**RE: Response to DEP Comments**  
**839 Saratoga Street**  
**Boston, MA 02128 – 1115**  
**MA DEP File No. 006 – 1774 / Boston Conservation File No. 2021 - 012**

On behalf of Volnay Capital (Applicant), RJ O'Connell & Associates, Inc. (RJO) is respectfully submitting this letter, revised plan set, and revised Operation & Maintenance Plan in response to comments provided by the Massachusetts Department of Environmental Protection (MA DEP) and the Boston Conservation Commission for the project referenced above.

More specifically, MA DEP issued comments on March 17, 2021 in regards to their review of the initially submitted Application. This letter summarizes MA DEP's comments in addition to including a response to each comment and concern.

## GRADING AND DRAINAGE PLAN

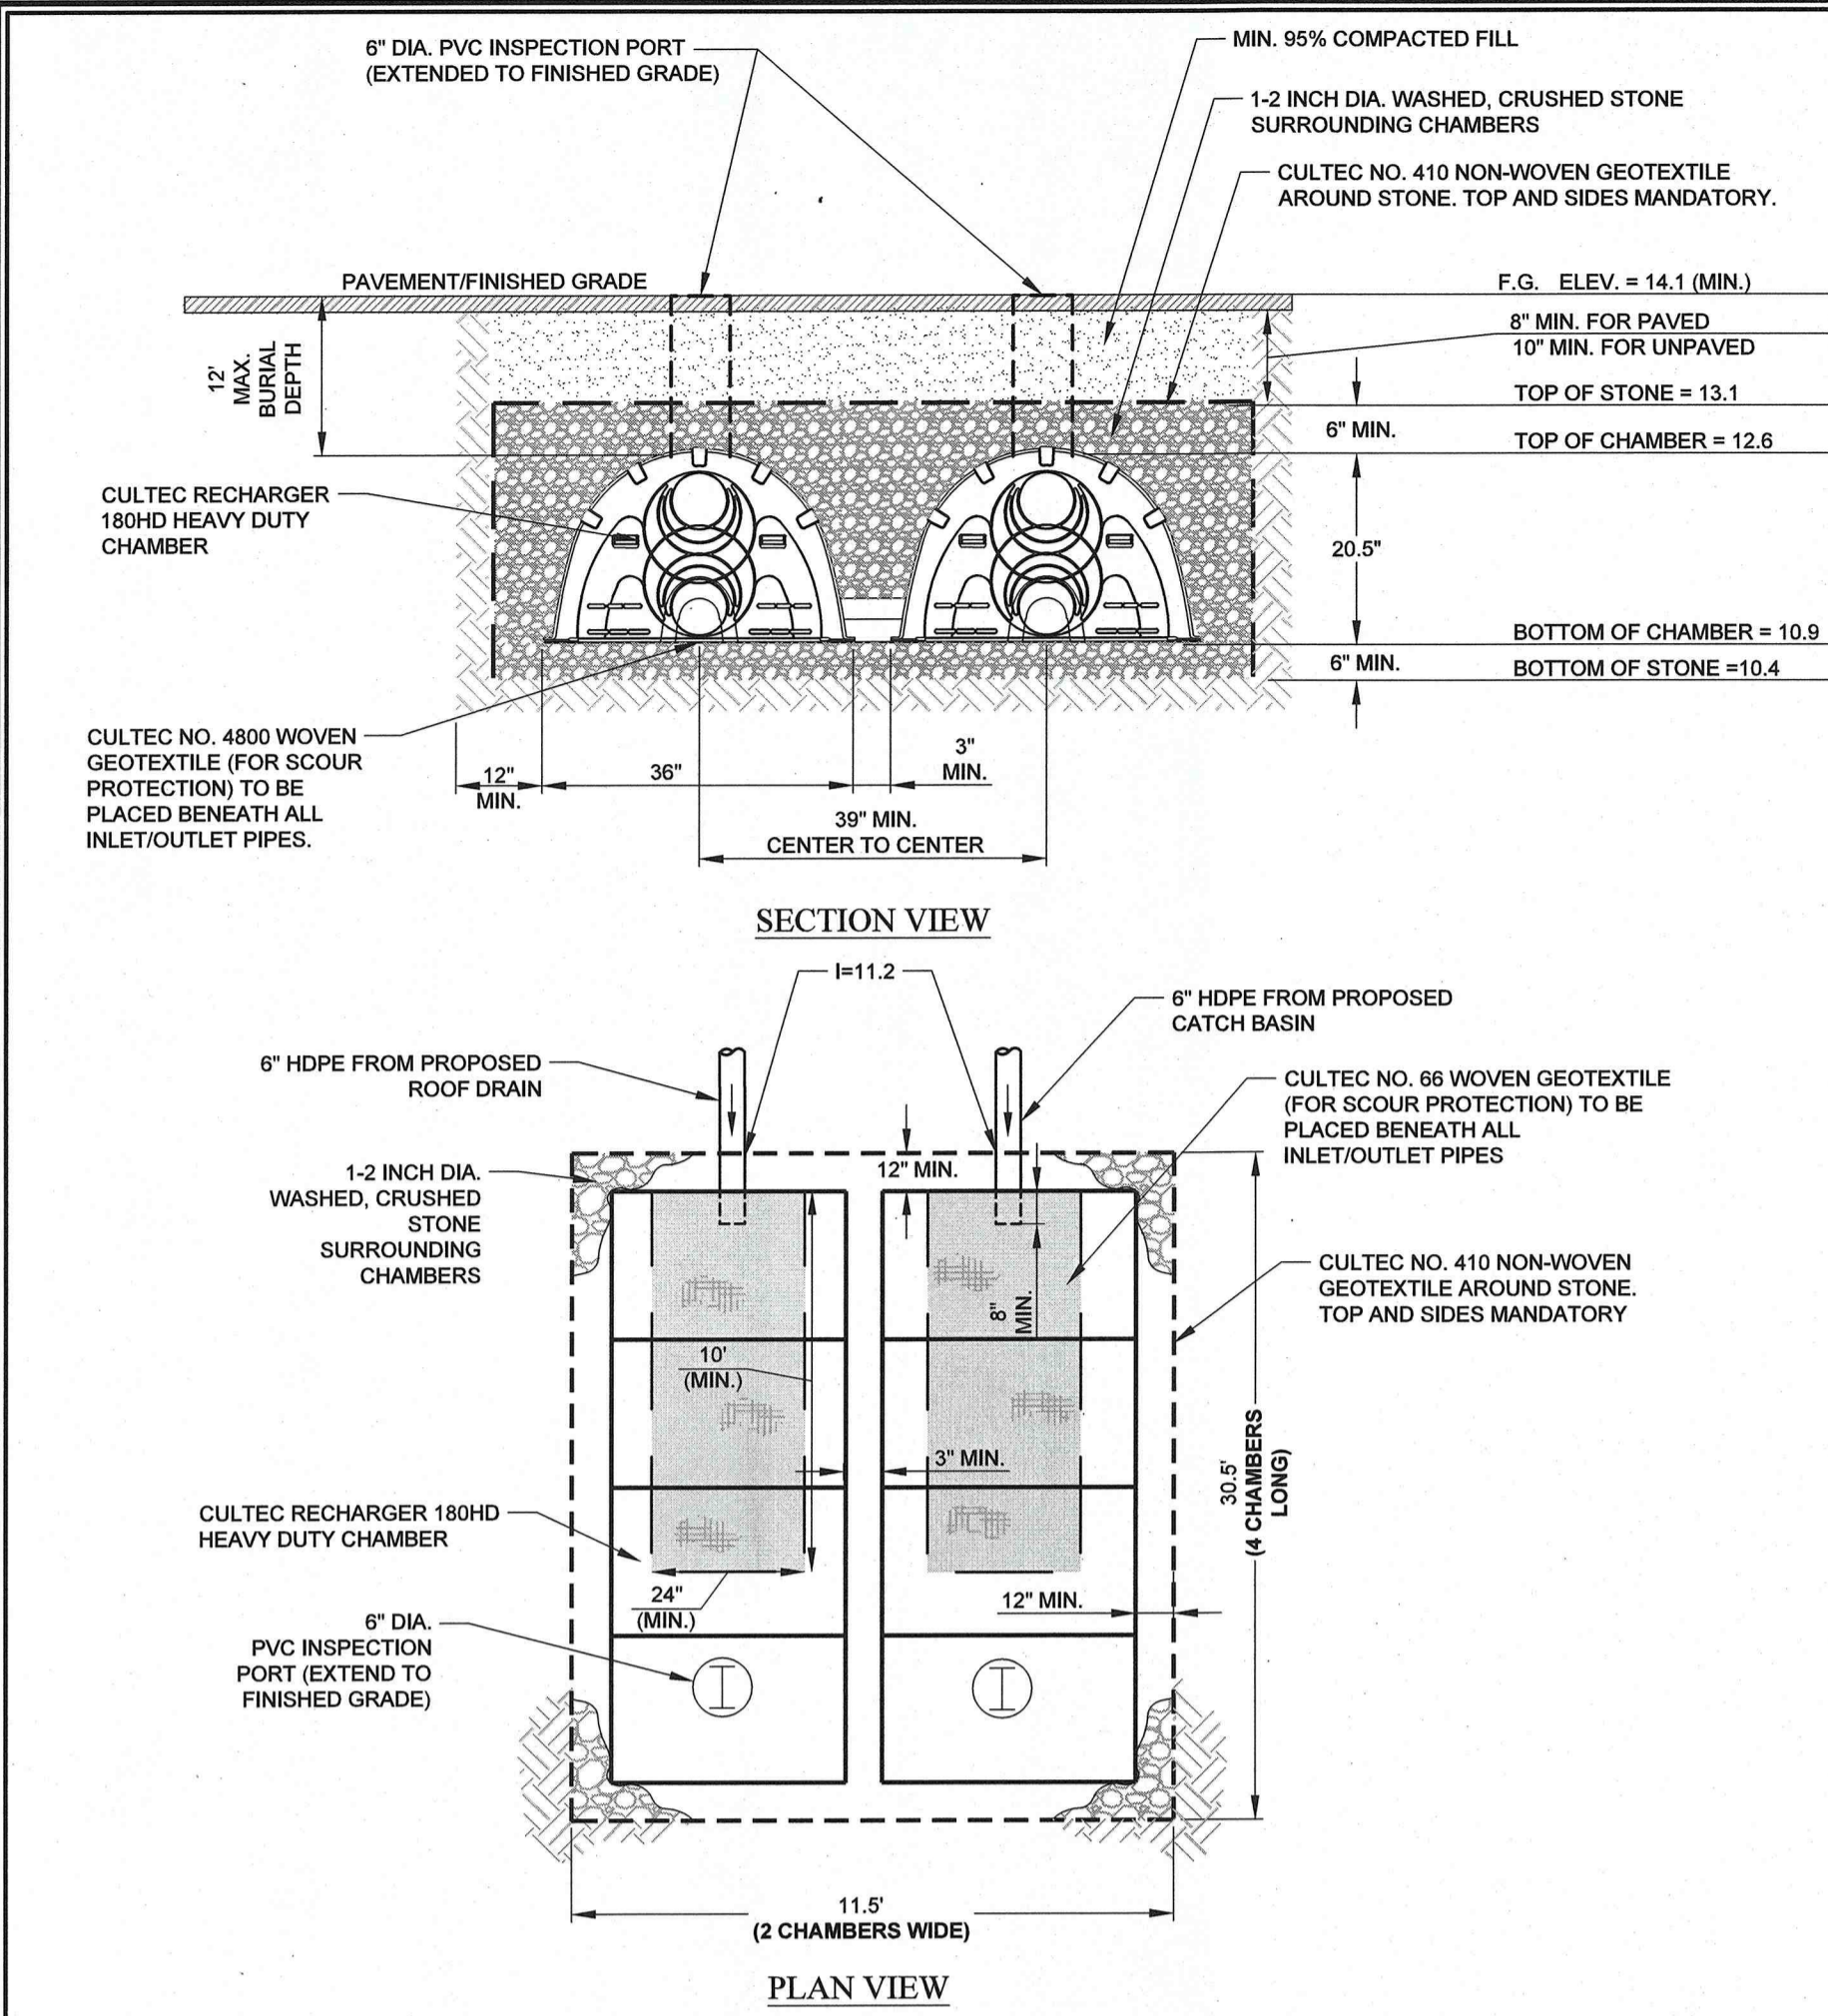
***Comment: No information was provided on how the project meets TSS removal requirements.***

**Comment:** *At least 2 test pits are required in the infiltration area, per the Stormwater Handbook, but no test pit data was submitted.*

***Response: The combined weighted TSS Removal Rate for the proposed drainage system will be approximately 82%.***

*The combined TSS Removal Rate was calculated as follows:*

- *For runoff from areas beyond the building (approx. 1,700 sf):*
  - *25% TSS from deep sump, hooded catch basin*
  - *80% TSS from drywell.*
  - *Combined TSS removal rate of 85%.*
- *For runoff from roofed areas (approx. 3,300 sf):*
  - *80% TSS from drywell.*

*The weighted TSS Removal Rate is calculated as follows:*

$$[(0.85 \times 1,700 \text{ sf}) + (0.80 \times 3,300 \text{ sf})] / 5,000 \text{ sf} = 0.82$$

**Response:** *Two (2) borings were performed on the Site by Geotechnical Partnerships, Inc.. Results of these borings are attached to this letter and confirm the soil characteristics used for the design of the proposed infiltration system.*
